ADDENDUM NO. 1
Amelia River Waterfront Stabilization Parking Lots C & D
City of Fernandina Beach
Invitation to Bid # 21-06
Issued: May 25, 2021

III. Changes to Drawings: (See attached)

Amelia River Waterfront Stabilization
Parking Lots C & D
Town/City: Fernandina Beach
County: Nassau State: Florida
Project No. 99000047.0095
Drawing No. **C2-2**
Date May 25, 2021

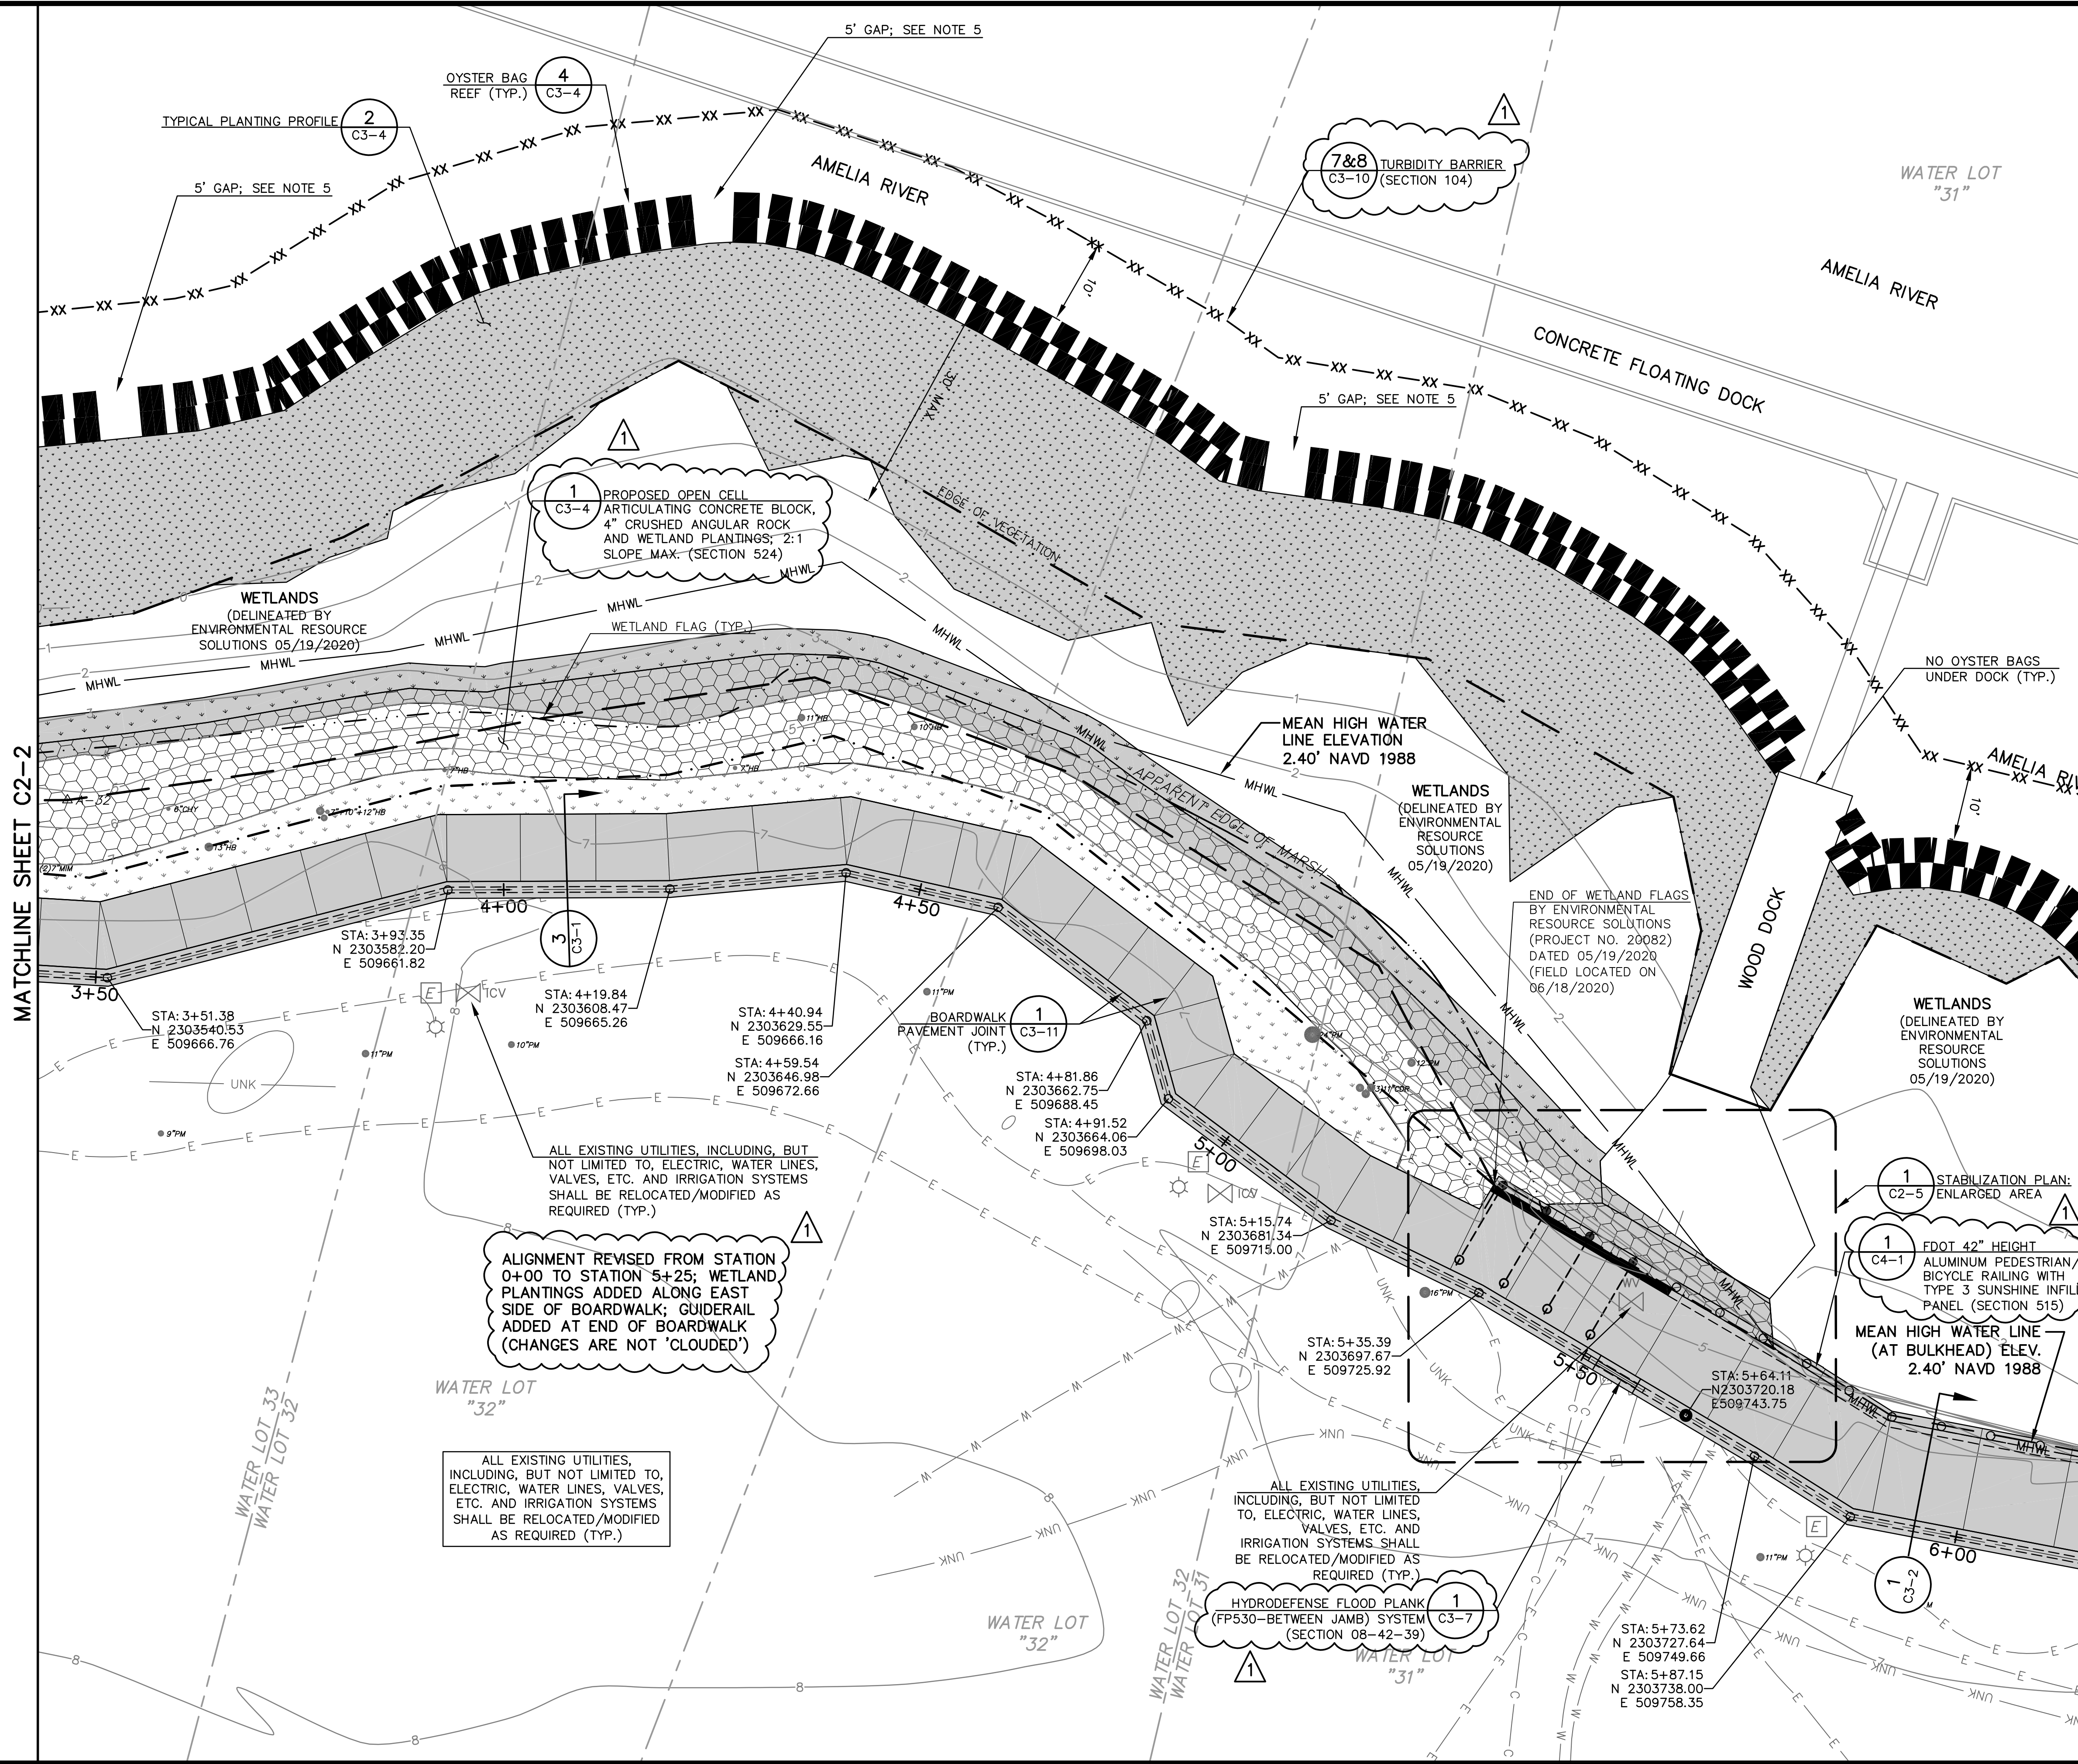
- 8) Sheet C2-2 – Revised I-Wall & Boardwalk Alignment; Wetland Planting Areas and Zones; Survey correction Wetland Flags; Tree Locations and Bid Form Section Tags.

BOARDWALK AND STABILIZATION PLAN
Amelia River Waterfront Stabilization
Parking Lots C & D
Town/City: Fernandina Beach
County: Nassau State: Florida
Project No. 99000047.0095
Drawing No. **C2-4**
Date May 25, 2021

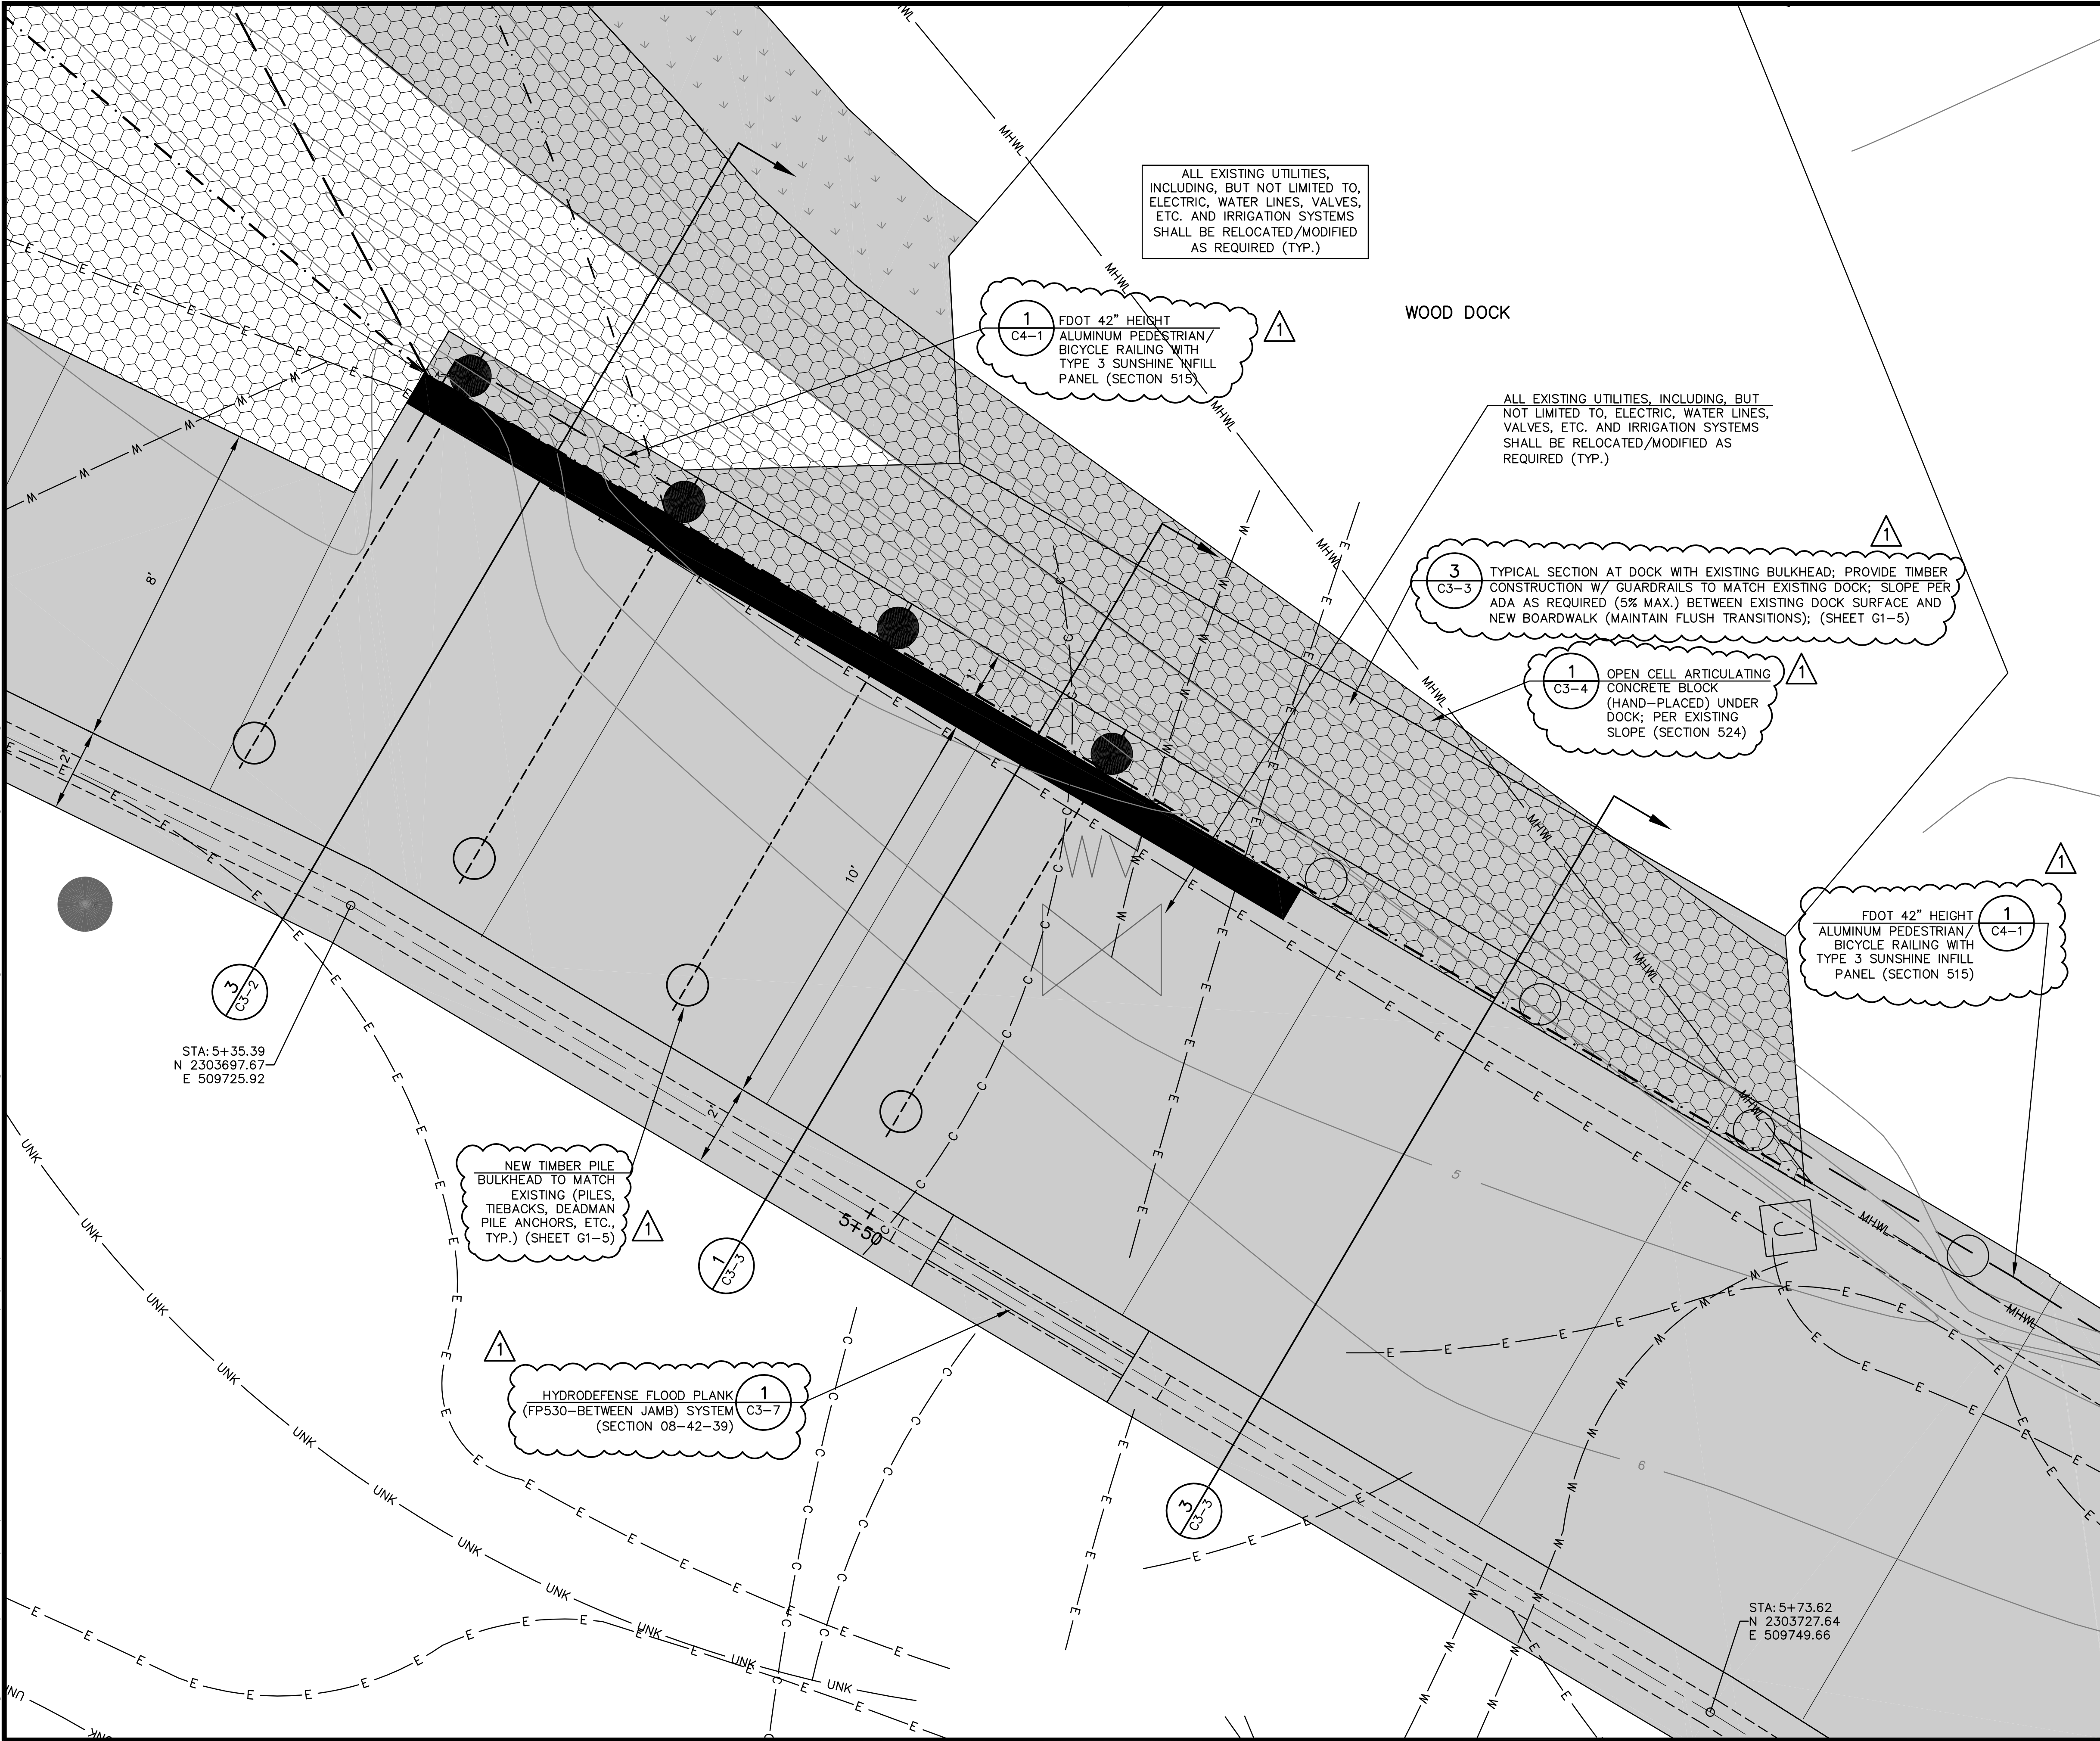
- 10) Sheet C2-4 – Revised I-Wall & Boardwalk Alignment; Wetland Planting Areas and Zones and Bid Form Section Tags.
- 11) Sheet C2-5 – Revised I-Wall & Boardwalk Alignment; Wetland Planting Areas and Zones; Survey correction Wetland Flags; Tree Locations and Bid Form Section Tags.

BOARDWALK PROFILE

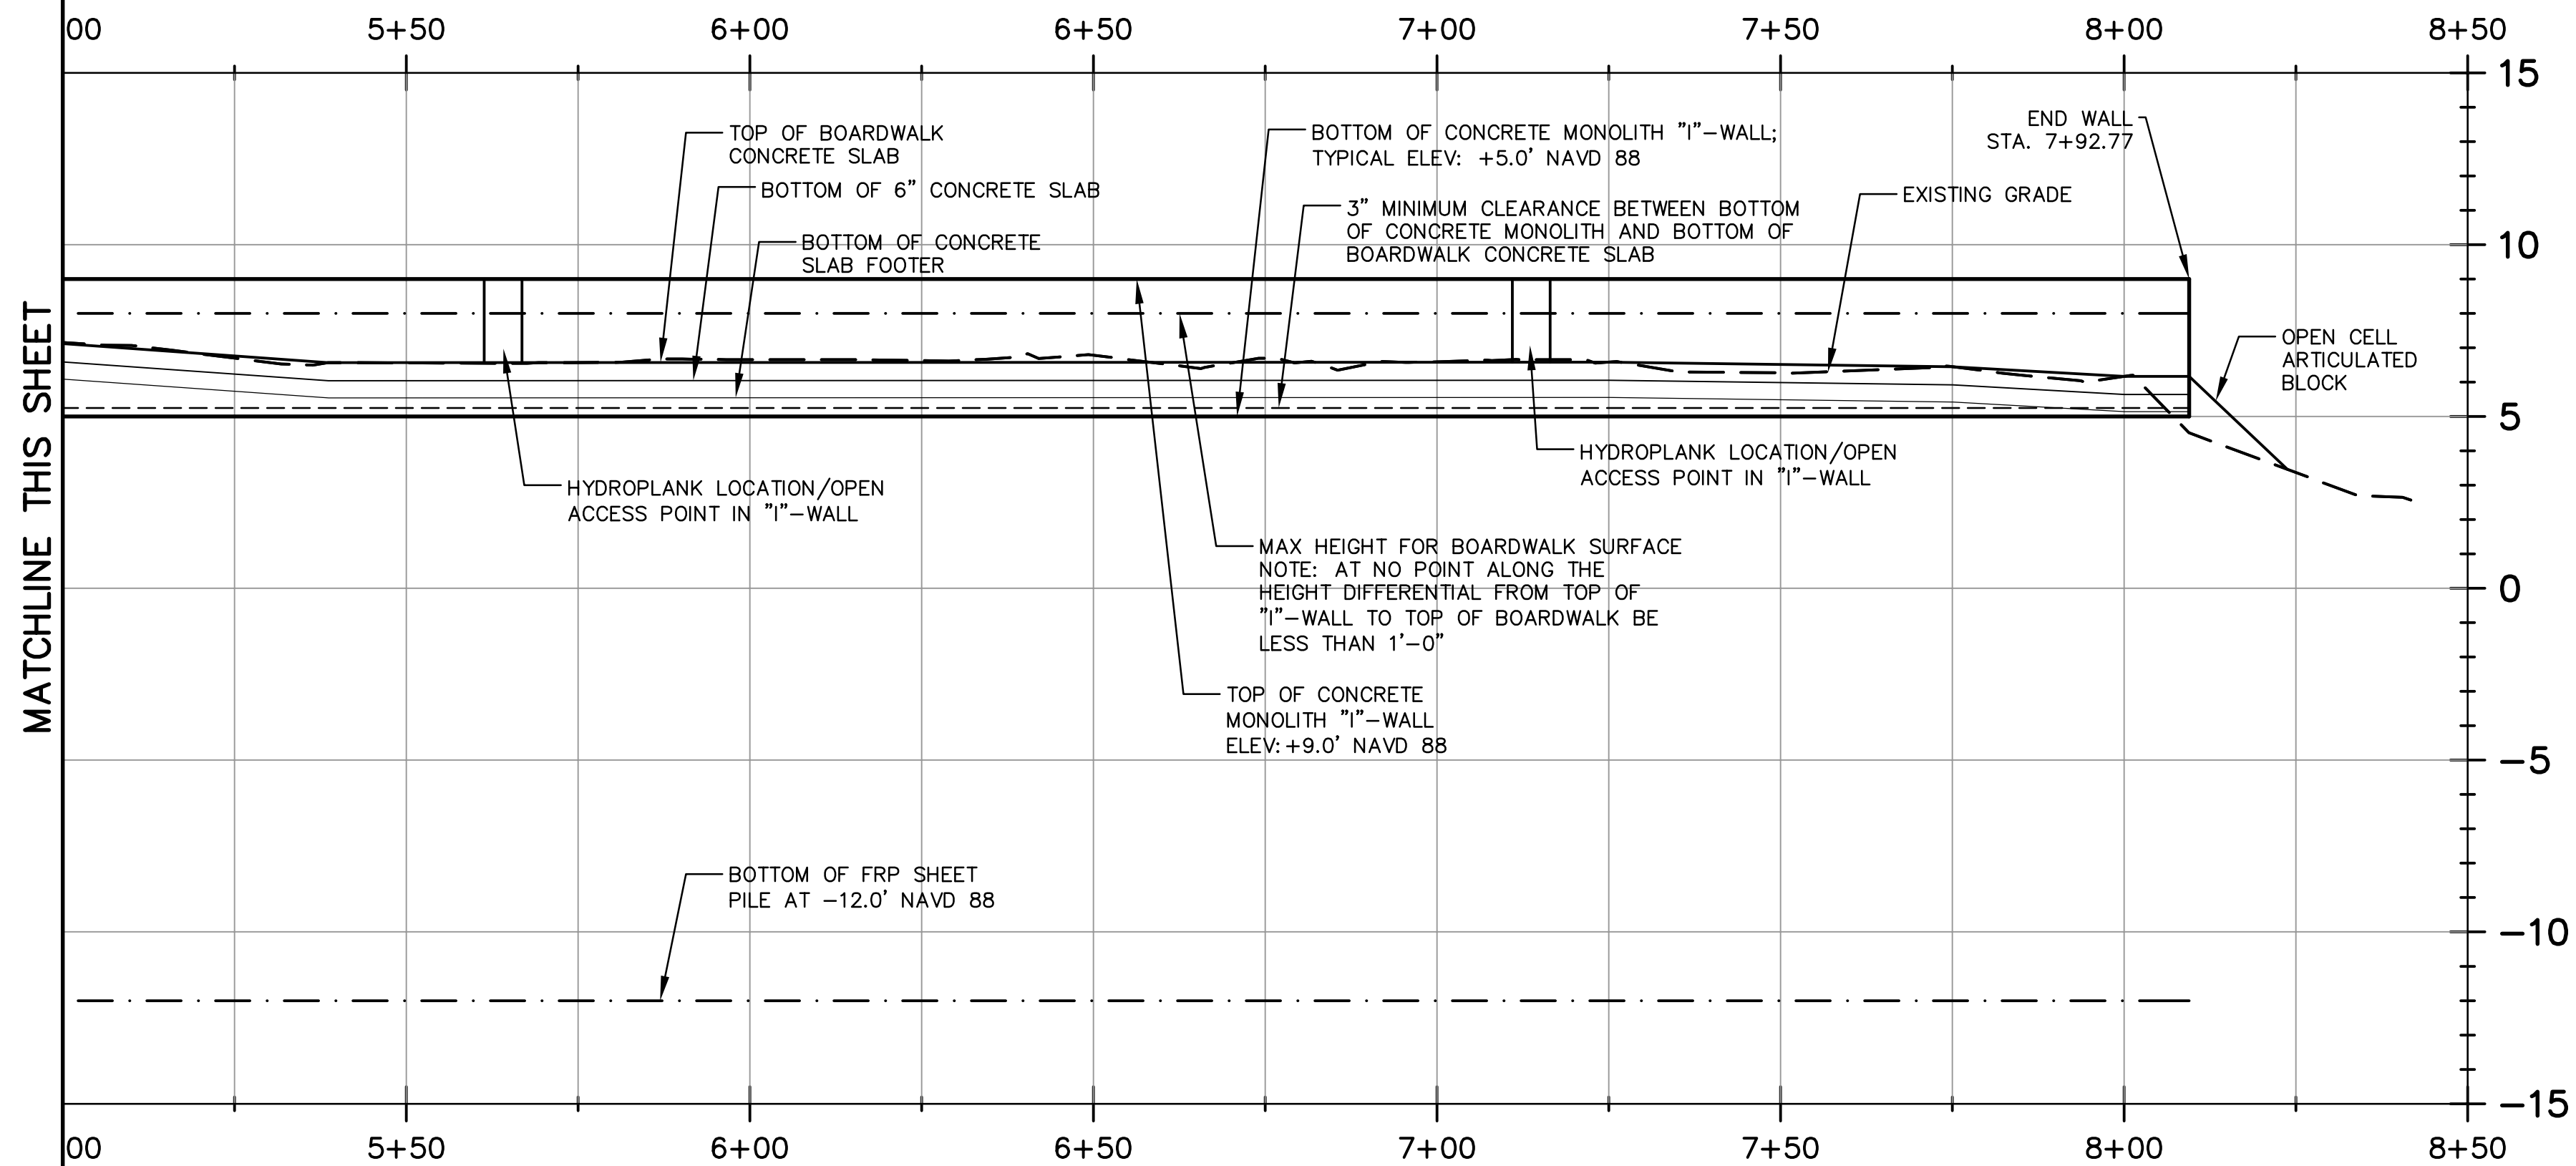
- 16) Sheet C3-5 – Revised Bid Section Number.
- 17) Sheet C3-6 – Revised Section Number.
- 18) Sheet C3-6 – Revised Item to Section Number.
- 19) Sheet C5-1 – Revised I-Wall & Boardwalk Alignment and Profile.
